Access Compliance Report Public Rights-of-Way (Curb Ramps)

Main Street: SIENNA_PKWY Cross Street: BLAKEMORE_DR Location: SW

ADA ID: RPRK211021142916 Ramp Type: Type 1 - Perpendicular Initial Pass/Fail: Fail Overall Compliance: No Severity Score: 15

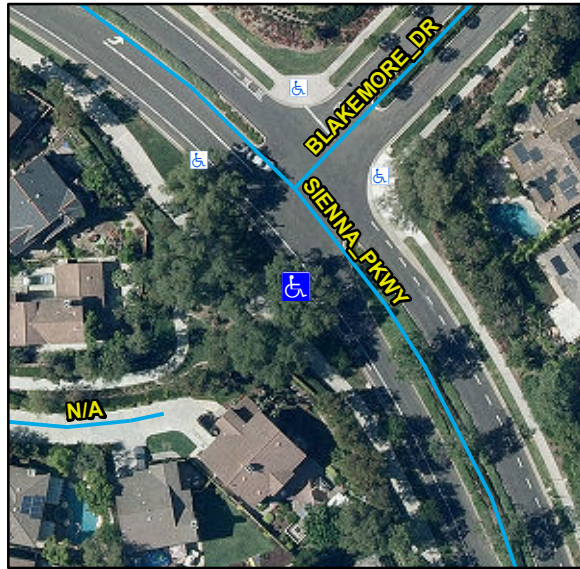
Compliance	Description	Data	Compliance	Description	Data
N/A	Ramp Length (in)	72	N/A	Flare Type LT	
Yes	Ramp Width (in)	48			N/A
No	Ramp Run Slope (%)	8.9	N/A	Flare Slope LT (%)	N/A
Yes	Ramp Cross Slope (%)	0.7	N/A	Flare Traversable LT	N/A
N/A	Landing Present	N/A	N/A	Flare Type RT	
N/A	Landing Length (in)	N/A			N/A
N/A	Landing Width (in)	N/A	N/A	Flare Slope RT (%)	N/A
N/A	Landing Run Slope (%)	N/A	N/A	Flare Traversable RT	N/A
N/A	Landing Cross Slope (%)	N/A	N/A	DWS Provided	N/A
N/A	Landing Movement Obstructed?	N/A	N/A	DWS Contrast	N/A
	Landing Movement Type	N/A	N/A	DWS Length (in)	N/A
N/A	Landing Shared	N/A	N/A	DWS Full Width	N/A
N/A	Clear Space	N/A	N/A	DWS Offset Left (in)	N/A
N/A	Clear Space To Crosswalk (in)	N/A	N/A	DWS Offset Right (in)	N/A
N/A	Marked Crosswalk 1	No	N/A	Marked Crosswalk 2	N/A
	Crossing 1 Direction	NE		Crossing 2 Direction	N/A
	Marked Crosswalk 1 Width (in)	N/A		Marked Crosswalk 2 Width (in)	N/A

N/A	Ramp Inside Crosswalk 1	N/A	Yes	Ramp Inside Crosswalk 2	N/A
	Crossing 1 Slope (%)	5.4		Crossing 2 Slope (%)	N/A
	Crossing 1 Cross Slope (%)	1.5		Crossing 2 Cross Slope (%)	N/A
N/A	Gutter Ponding	N/A	No	Curb Slope	17.1
Yes	Gutter Lip Height (in)	0		Road Run Slope (%)	N/A
N/A	Gutter Run Slope (%)	N/A		Road Cross Slope (%)	N/A
N/A	Gutter Cross Slope (%)	N/A			
Yes	Overall Surface Condition: Acceptable		No	Perp Joint Present	No
	Cross Gutter Present?	No		Spandrel Present?	No
	Replace Cross Gutter?	N/A		Replace Spandrel?	N/A

Remove & Replace Entire Ramp.
